SUBMITTAL TRANSMITTAL

Submittal No: 05500-009.A

PROJECT: **Harold Thompson Regional WRF**
Birdsall Rd.
Fountain, CO 80817
Job No. 2908

SUBJECT: Re-submittal for the Aeration Basin/Digester Stairs

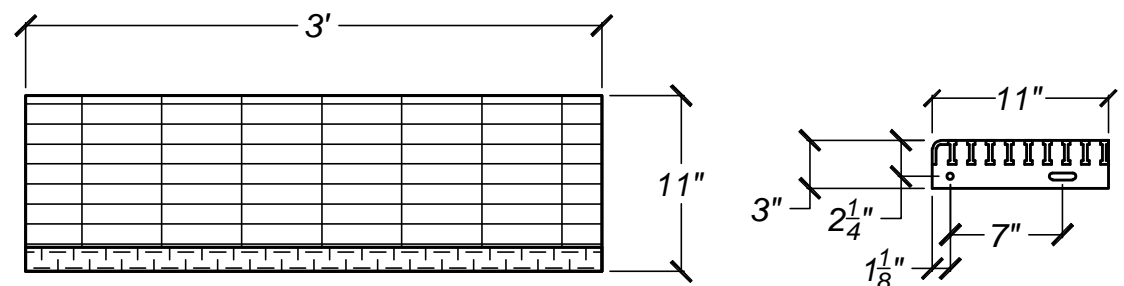
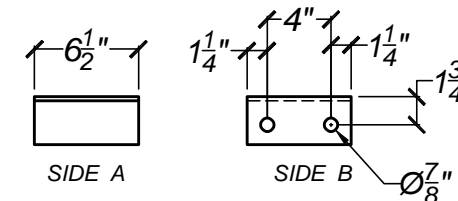
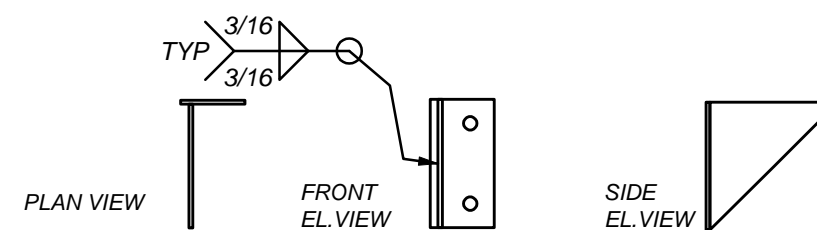
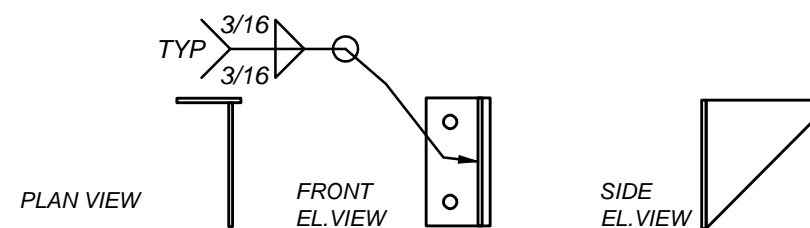
1. We acknowledge the WCMI comments provided on page 2 of the shop submittal.
2. Sheet S-6: **No Exception Taken** **Changed stair tread description & added note.**

(36 REQ.) 1-1/2" x 3/16" ALUM. SERRATED TREADS or STRIATED I-BAR STAIR TREADS - 6T1

Project	HAROLD D. THOMPSON REGIONAL RECLAMATION FACILITY	Date	1/23/2012
Area	LOWER FOUNTAIN METROPOLITAN SEWEGE DISPOSAL DISTRICT	Drwn By	DWN
Detail	DETAILS --- STAIRS PER 1/AB-7	Rev:	2
Ref Dwg	NOTED	Date:	3/21/2012
Scale	NONE	Sheet	S-7

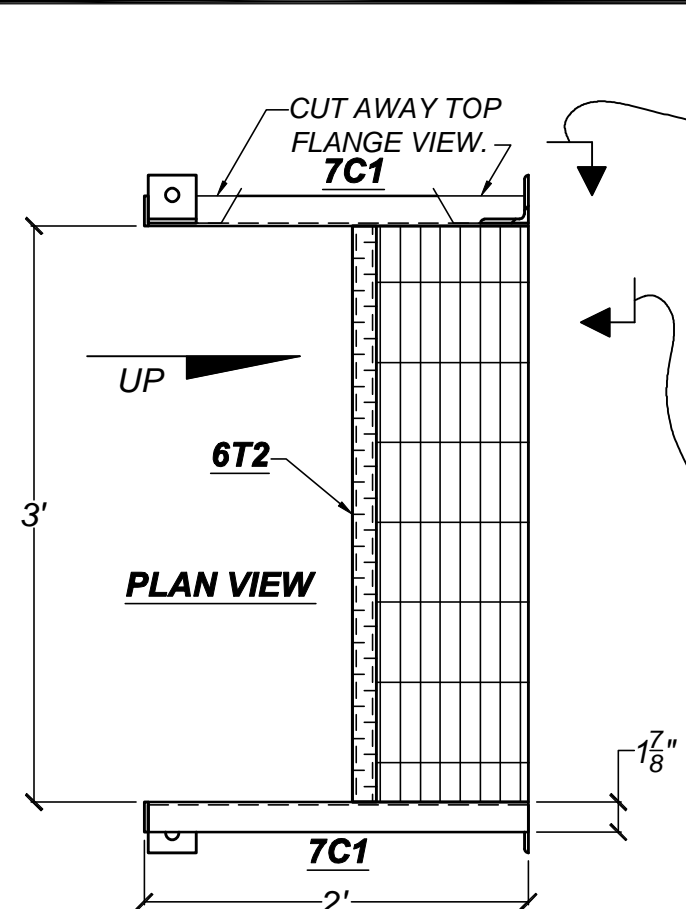
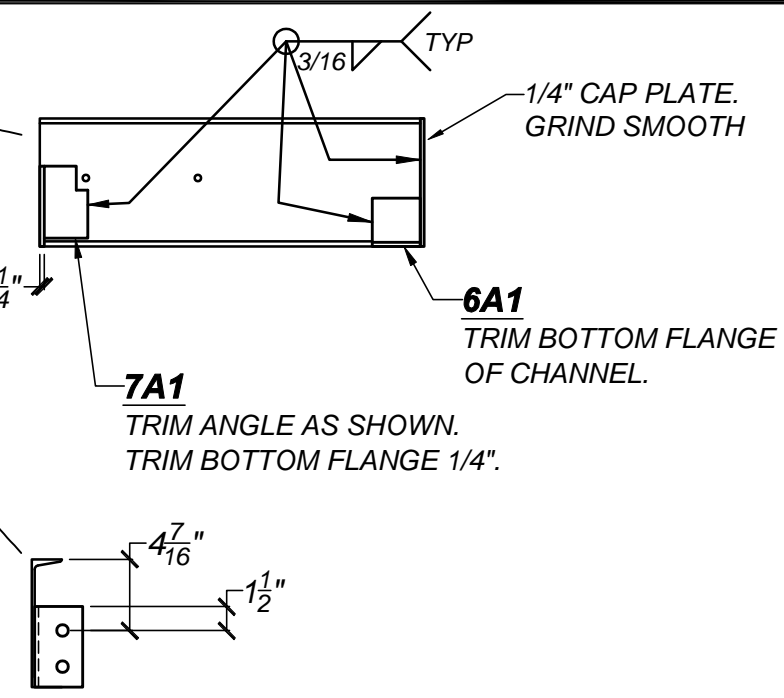
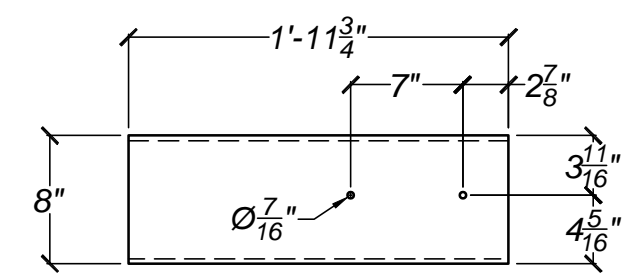
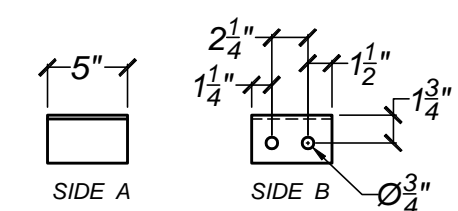
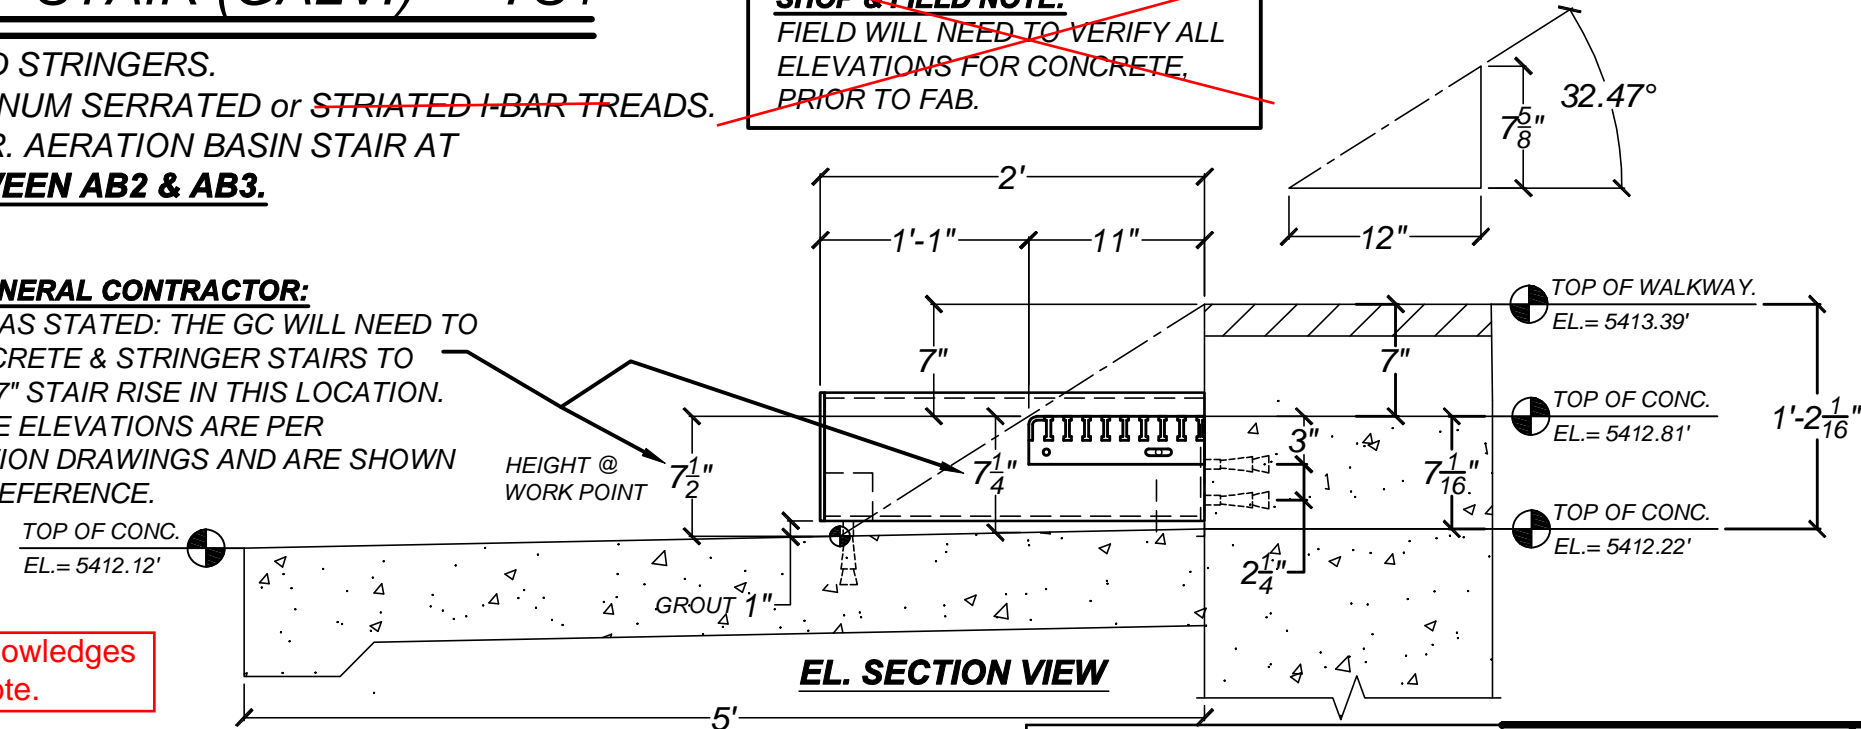
3. Sheet S-7: **Revise and Resubmit** **Changed per this document & added notes.**
 - a. The plan view of the stair indicates 1½-inch aluminum I-bar non-slip treads will be utilized. All stair treads must be serrated aluminum tread. This also applies to the elevation section view.

- b. The fabricator has made note to the Engineer that there may be a potential code violation. Per the project specifications, the maximum rise per step is 7 inches. The concrete and placement of the stringer and C-channel must be modified accordingly to provide for a maximum rise per step to equal 7 inches maximum.

GALVANIZED STRINGERS.
 1-1/2" ALUMINUM SERRATED or ~~STRIPED I-BAR~~ TREADS.
 1/AB-7 STAIR. AERATION BASIN STAIR AT
WALL BETWEEN AB2 & AB3.

NOTE TO GENERAL CONTRACTOR:
 ENGINEER HAS STATED: THE GC WILL NEED TO PLACE CONCRETE & STRINGER STAIRS TO PROVIDE A 7" STAIR RISE IN THIS LOCATION. NOTE: THESE ELEVATIONS ARE PER CONSTRUCTION DRAWINGS AND ARE SHOWN HERE FOR REFERENCE.

Project	HAROLD D. THOMPSON REGIONAL RECLAMATION FACILITY	Date	1/23/2012
Area	LOWER FOUNTAIN METROPOLITAN SEWEGE DISPOSAL DISTRICT	Drwn By	DWN
Detail	DETAILS --- STAIRS PER 2/AB-7	Rev: 2	Date: 3/21/2012
Ref Dwg	NOTED	Scale	NONE
Sheet	S-8

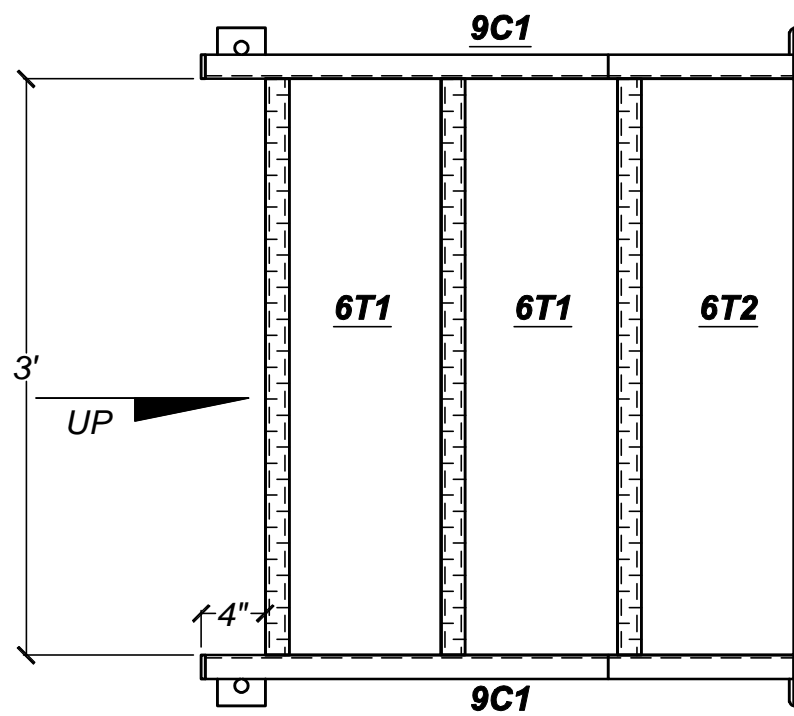
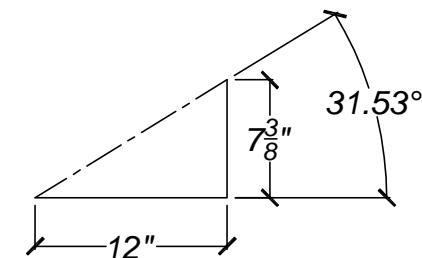
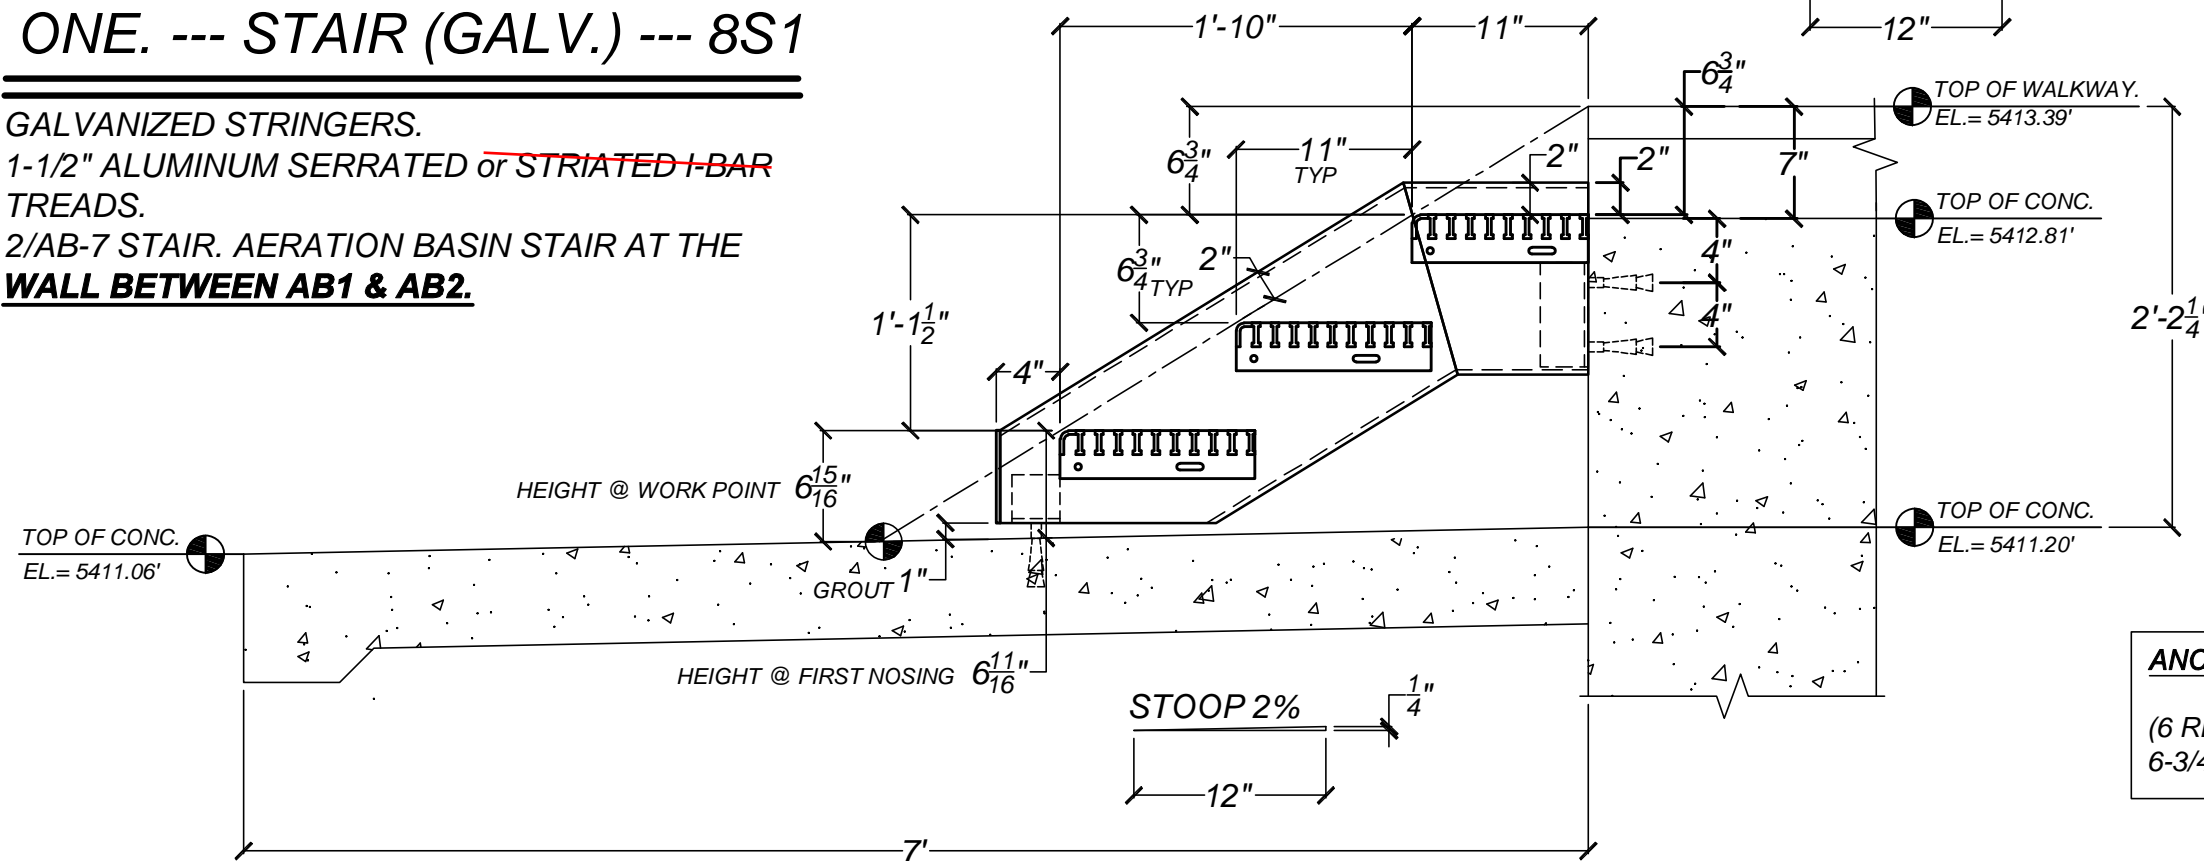
4. Sheet S-8: **Revise and Resubmit** **Changed per this document & added note.**
 - a. The plan view of the stair indicates 1½-inch aluminum I-bar non-slip treads will be utilized. All stair treads must be serrated aluminum tread. This also applies to the elevation section view.

- b. Detail 2/AB-7 represents a typical stair section at two different stair locations. The top of concrete elevation shown in the elevation view may vary. The Contractor must verify the as-constructed elevations of all concrete surfaces at each location.

1-1/2" ALUMINUM SERRATED or ~~STRIPED~~ I-BAR TREADS.

Project	HAROLD D. THOMPSON REGIONAL RECLAMATION FACILITY	Date	1/23/2012
Area	LOWER FOUNTAIN METROPOLITAN SEWEGE DISPOSAL DISTRICT	Drwn By	DWN
Detail	DETAILS --- STAIRS PER 2/AB-7	Rev:	2
Ref Dwg	NOTED	Date:	3/21/2012
Scale	NONE	Sheet	S-10

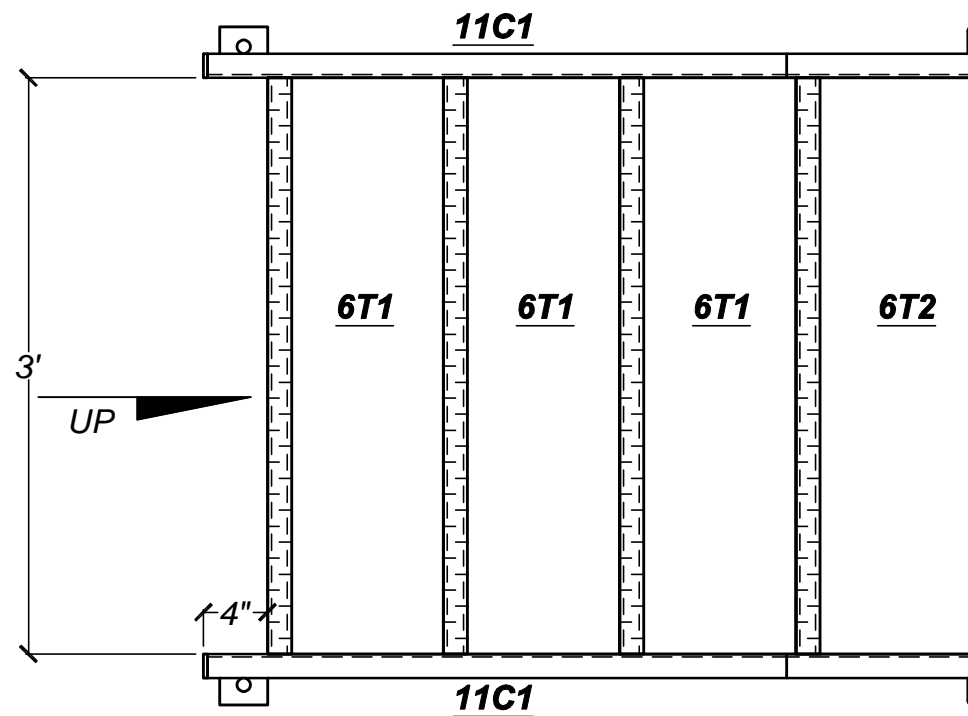
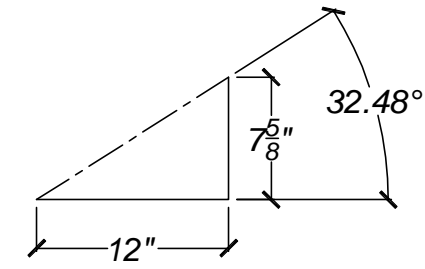
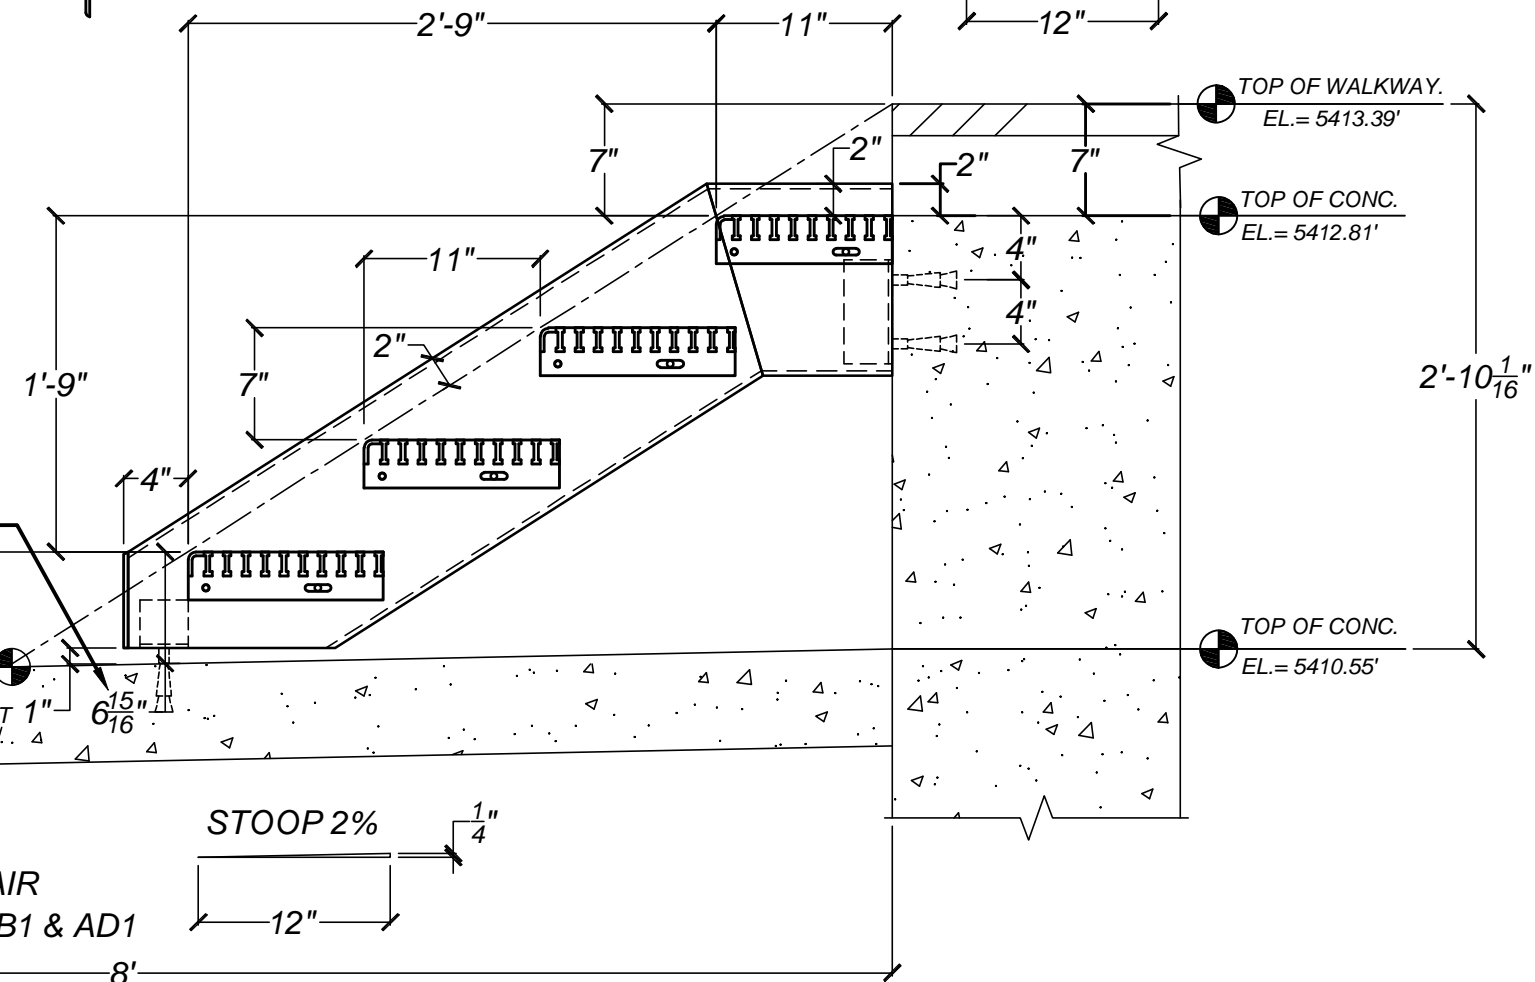
5. Sheet S-9: **No Exception Taken** No change.
6. Sheet S-10: **Revise and Resubmit** Changed per this document & added notes.
- a. The plan view of the stair indicates 1½-inch aluminum I-bar non-slip treads will be utilized. All stair treads must be serrated aluminum tread. This also applies to the elevation section view.

- b. As previously noted, Detail 2/AB-7 represents stairs at two stair locations. The top of concrete elevations must be verified at each location to confirm all elevations.

- c. The bottom step has a rise of $7\frac{3}{16}$ inches, where 7 inches is the maximum. The Contractor must make all necessary modifications to adjust concrete, stair stringers, etc., to provide for a maximum of 7 inches of rise per the project specifications.

1-1/2" ALUMINUM SERRATED or ~~STRIATED I-BAR~~ TREADS.

ENGINEER HAS STATED: THE GC WILL NEED TO PLACE CONCRETE & STRINGER TO PROVIDE A 7" STAIR RISE IN THIS LOCATION.
NOTE: THESE ELEVATIONS ARE PER CONSTRUCTION DRAWINGS AND ARE SHOWN HERE FOR REFERENCE.
